South Armour Heights Residents' Association

File Number: A0596/15NY; Property Address: 1912 & 1914 Avenue Road on Aug 6, 2015

SAHRA is writing to advise the Committee that it strongly opposes the above noted application for 15 significant variances that are contrary to the requirements for a 5-storey building as defined by the Avenue Road Study 2009 and Zoning By-laws 569-2013 and 7625.

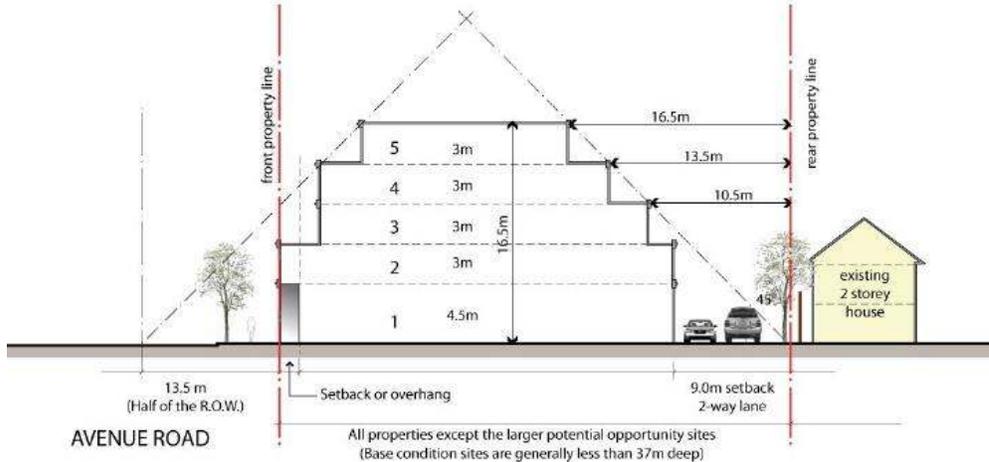
*The maximum height as per regulation 40.10.40.10.(2) is 5 storeys or 16.5m, whichever is lesser in height applies, a mechanical penthouse or other rooftop structures is not included in the permitted maximum height and the mechanical penthouse or other rooftop structure must not exceed this height limit by more than 2m.*

The proposed building is 19.4 to the top (**vs 16.5 so 2.9m higher**) and 23.6m to the top of the mechanical penthouse, which is 4.2m above the roof (**vs 18.5 so 5.1m higher**).

**This is not a minor variance – it is a significant increase of some 27%. The mechanical height (4.2 vs 2 max) is twice the allowed height.**

The developer has provided for a tall ground floor (4.5m/14.76 feet which is as per the Avenue Road Study guidelines) but then has gone for greater floor to ceiling heights for the office floors of 3.6m on the 2<sup>nd</sup>, 3<sup>rd</sup> and 4<sup>th</sup> floors (11.6 feet) and 3.9 on the 5<sup>th</sup> floor (12.8 feet) as opposed to the Avenue Road Study guidelines of 3m (9.84 feet) for each floor. The heights for these floors should be adjusted to 3m to fit within the 16.5m by-law definition.

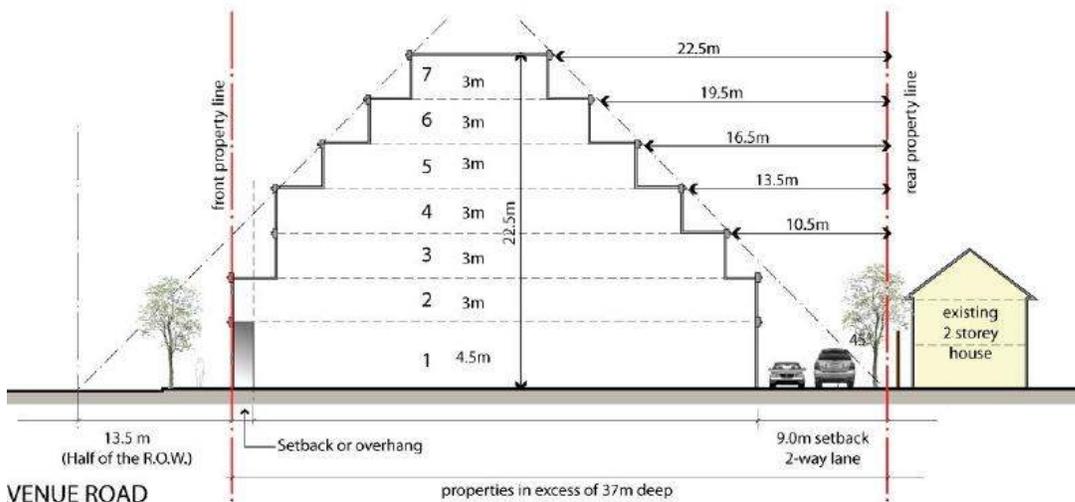
The maximum allowed for the mechanical penthouse/other rooftop structure is 2m. The drawings appear to illustrate what looks to be like a 'two-level structure'. The planner and architect for the developer stated that due to the mechanicals that are required for the totally commercial site, the mechanical penthouse and rooftop structure cannot be less than 3.6 to 4.2m according to their consultants. If additional height is required due to the nature of commercial mechanicals, the number of floors should be reduced to 4 to allow for this.

This 5-storey building proposal of 19.4m (excluding mechanical) is actually close to the maximum height allowed for a **7-storey building (22.5m)** for properties in excess of 37m depth (with the same defined floor heights).

If the higher ceiling heights are critical to the design and the mechanical height cannot be adjusted to the allowed maximum, the developer should modify the design to provide for 4 floors.
